ADDENDUM NO. SEVEN

October 8, 2024

Lamont Park Beautification Project

1650.7012.22

JOB	LCD.04
DP	
PM MM AC	
11 OF 36

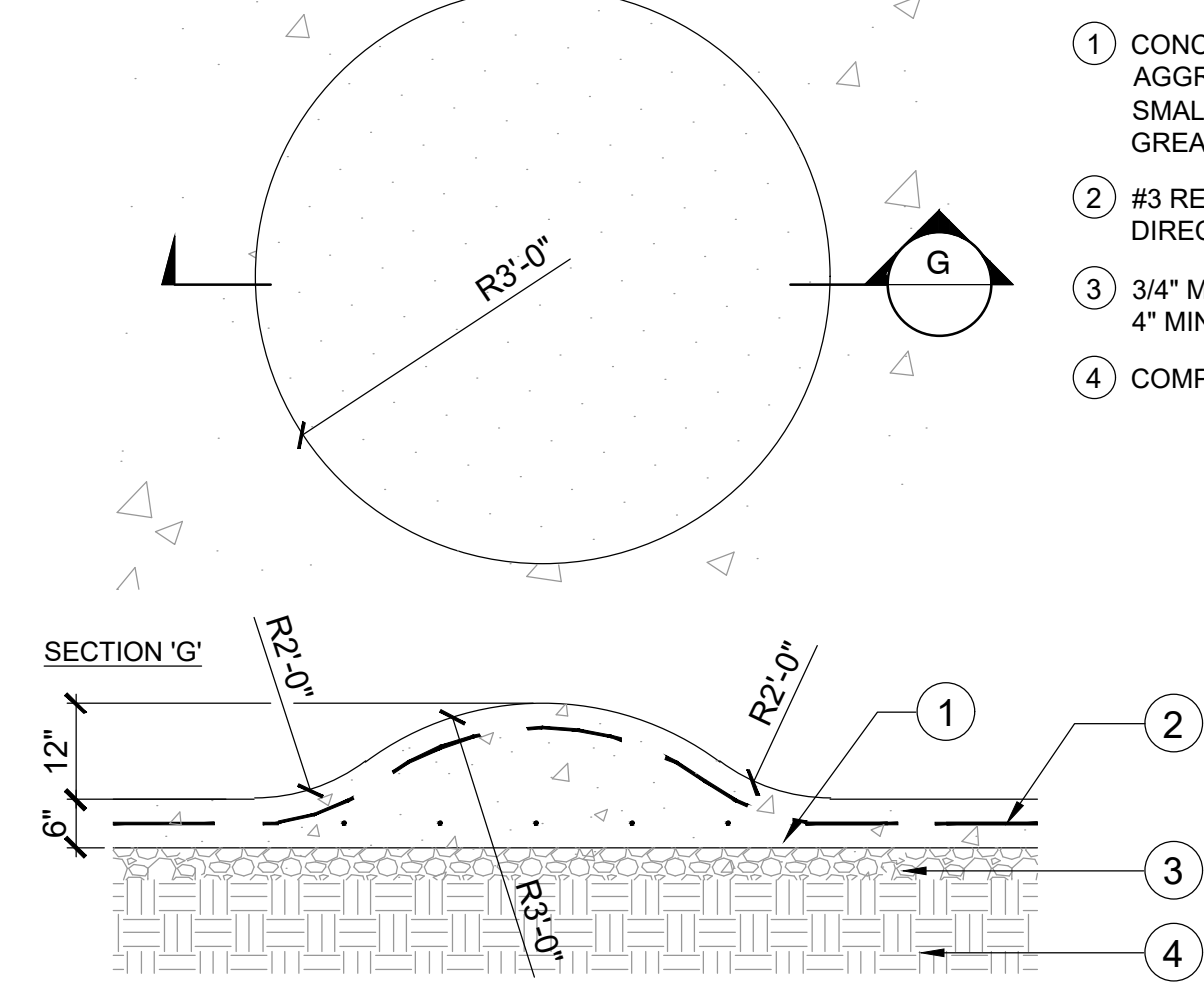
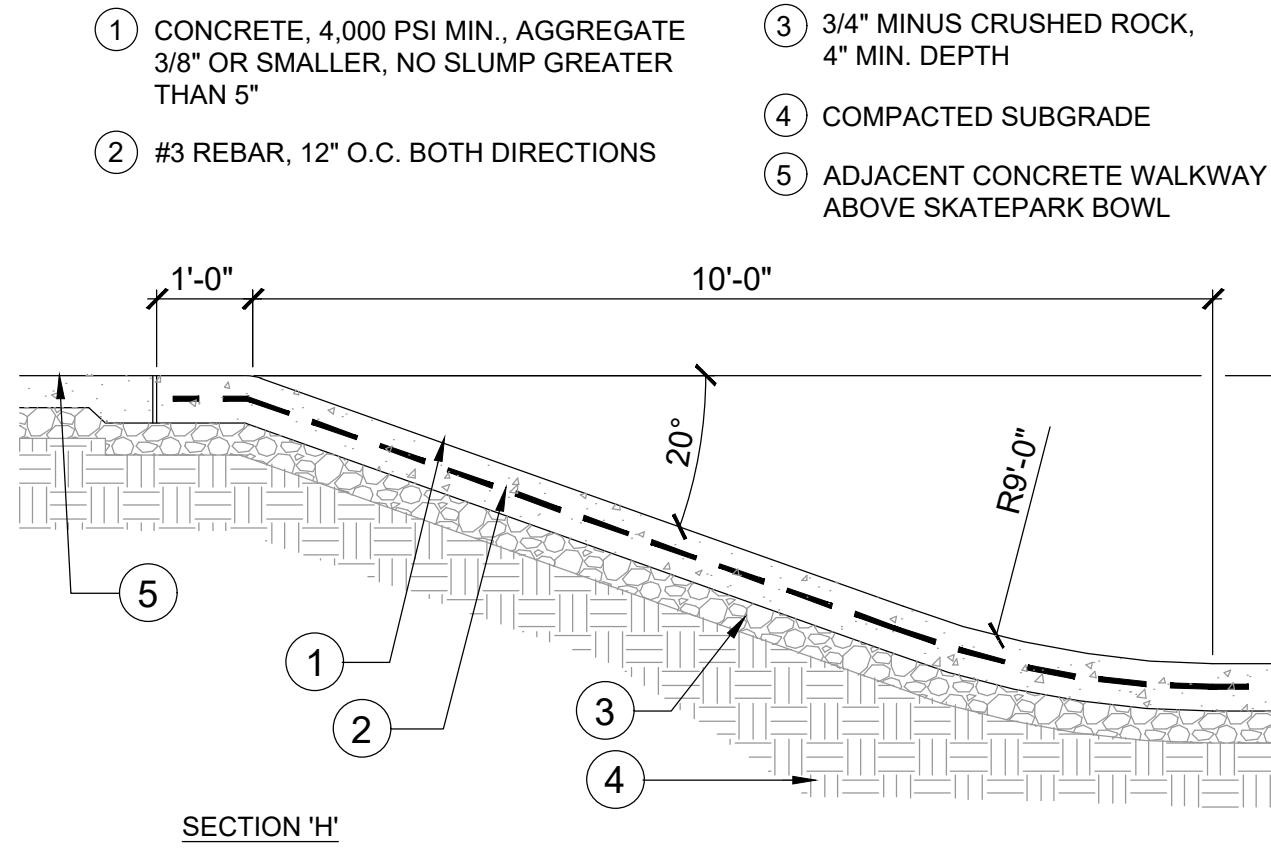
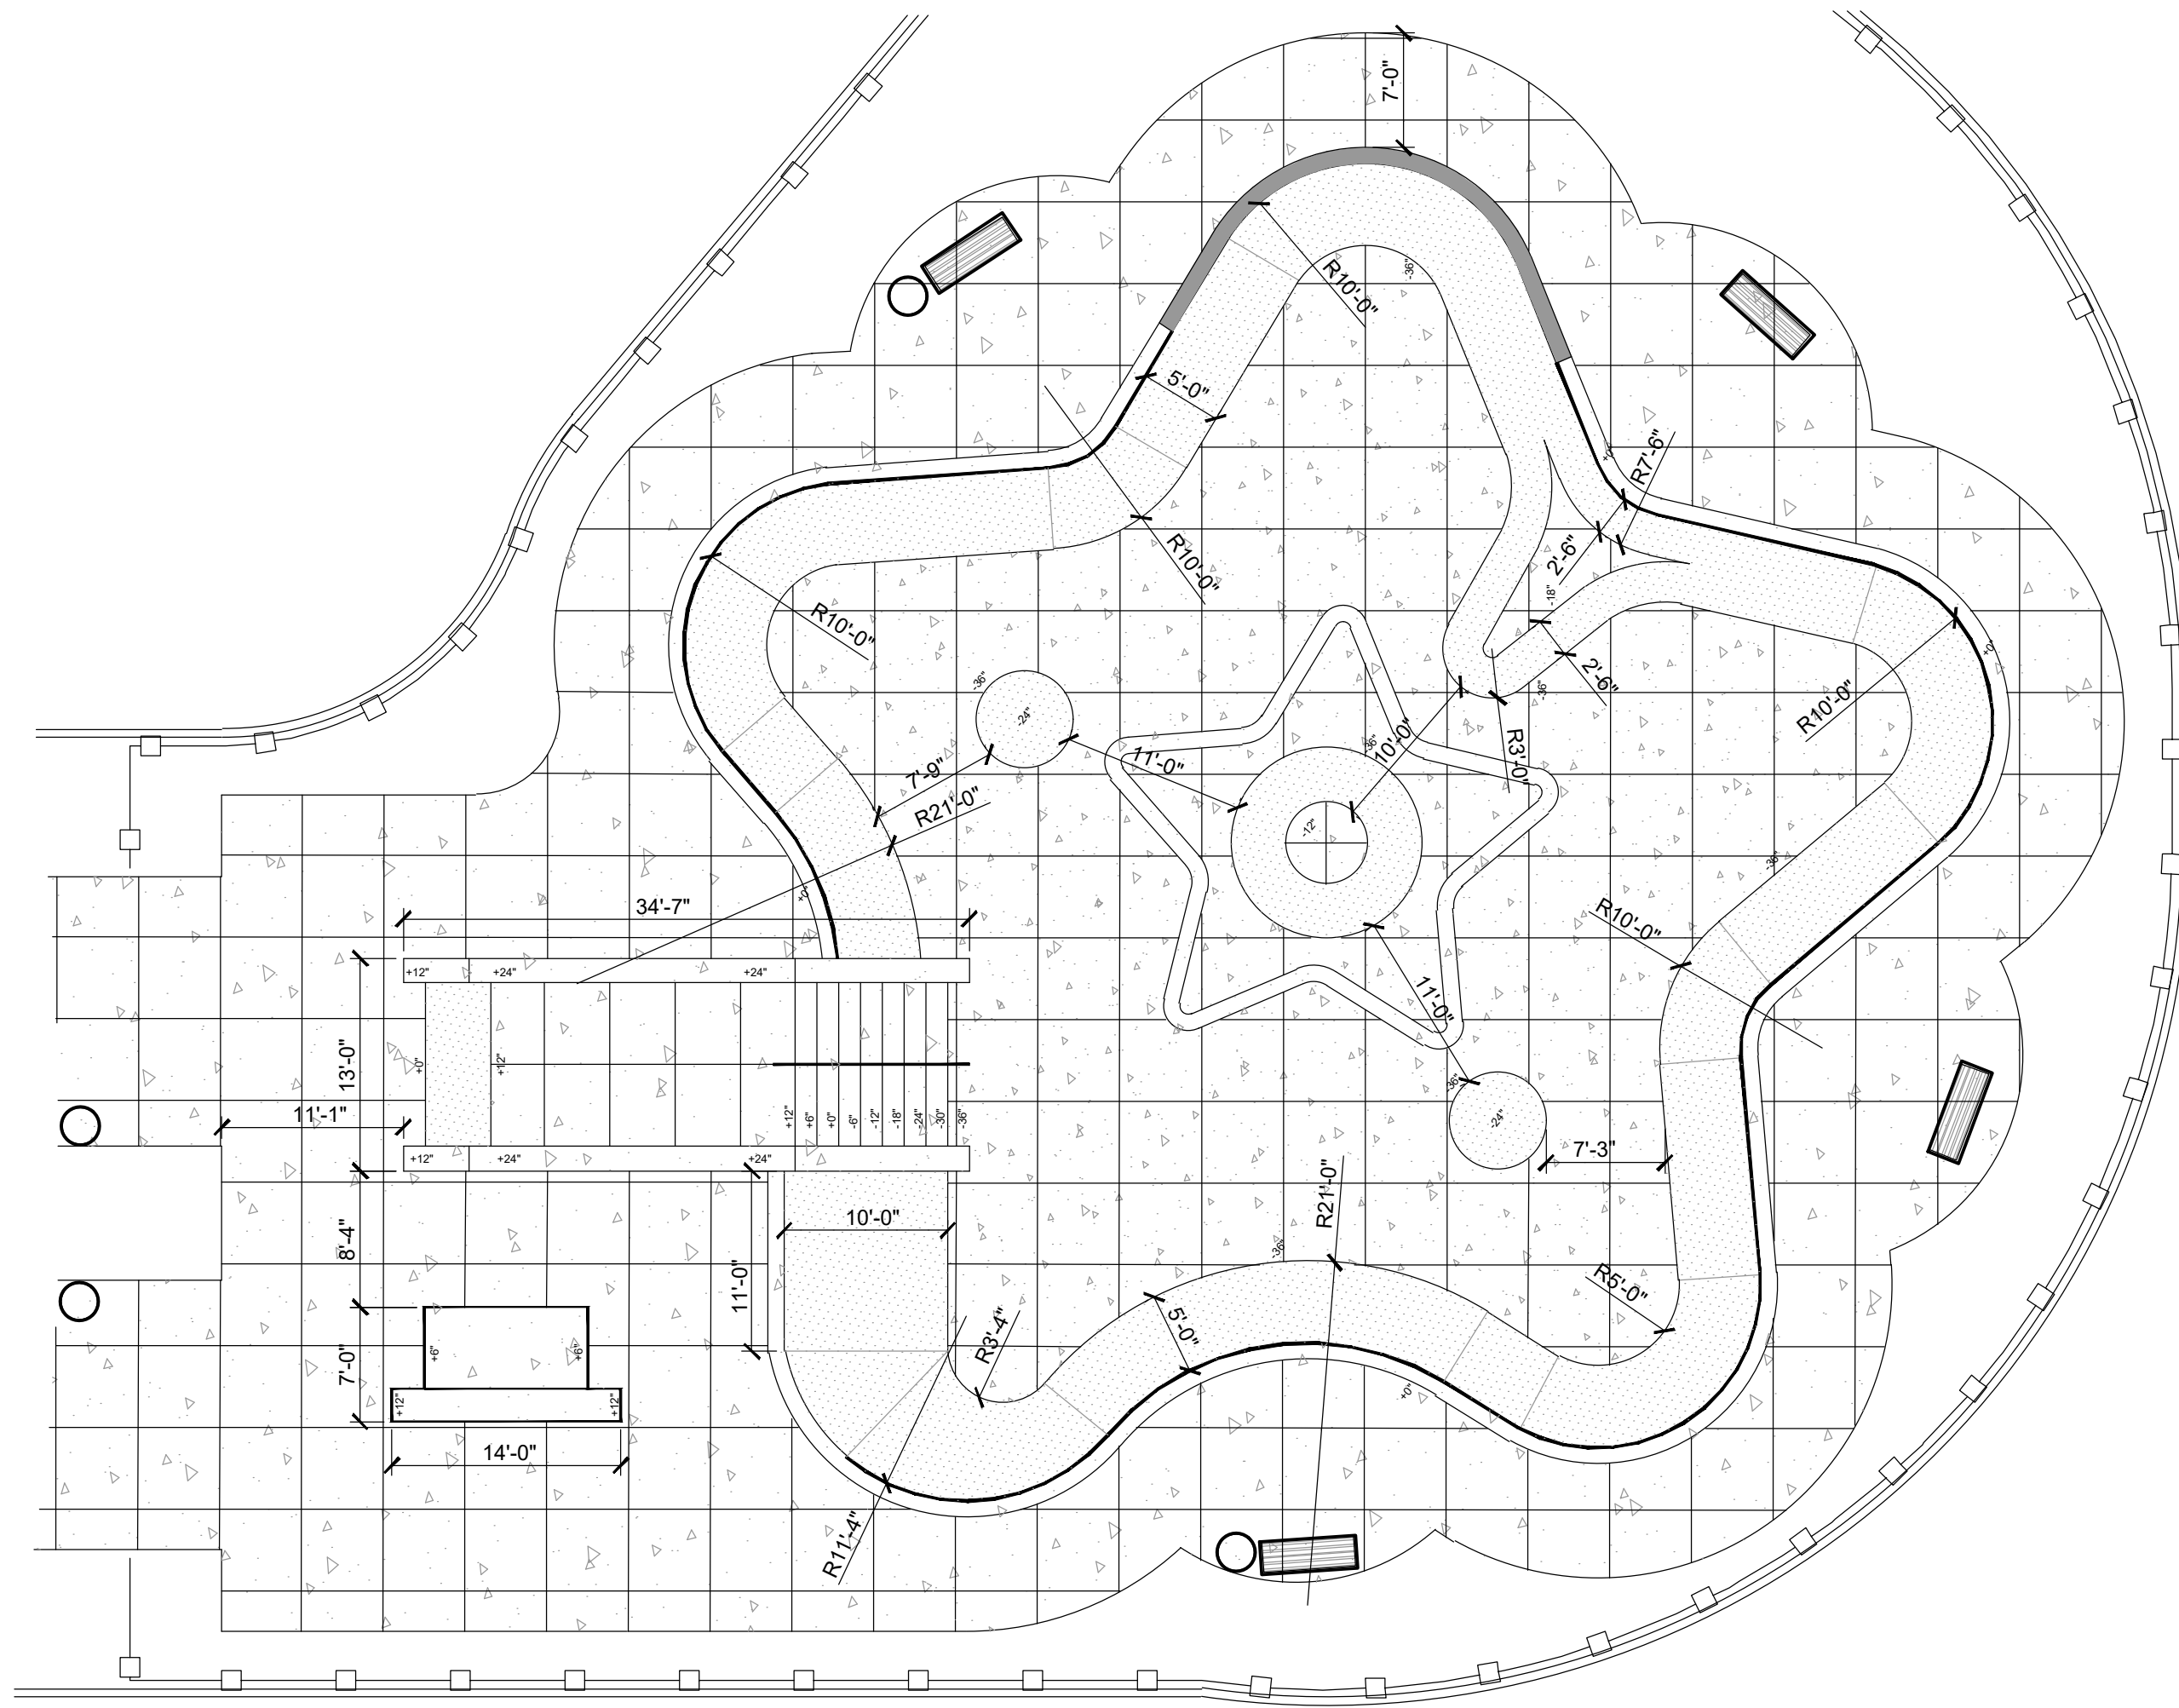
- Item No. 9:** Refer to attached sheet LI.02 and replace existing sheet LI.02 in its entirety.
- Item No. 10:** Refer to attached sheets LCD.04 and LCD.07 and replace existing sheet LCD.04 and LCD.07 in their entirety. Refer to revision clouds for modifications.
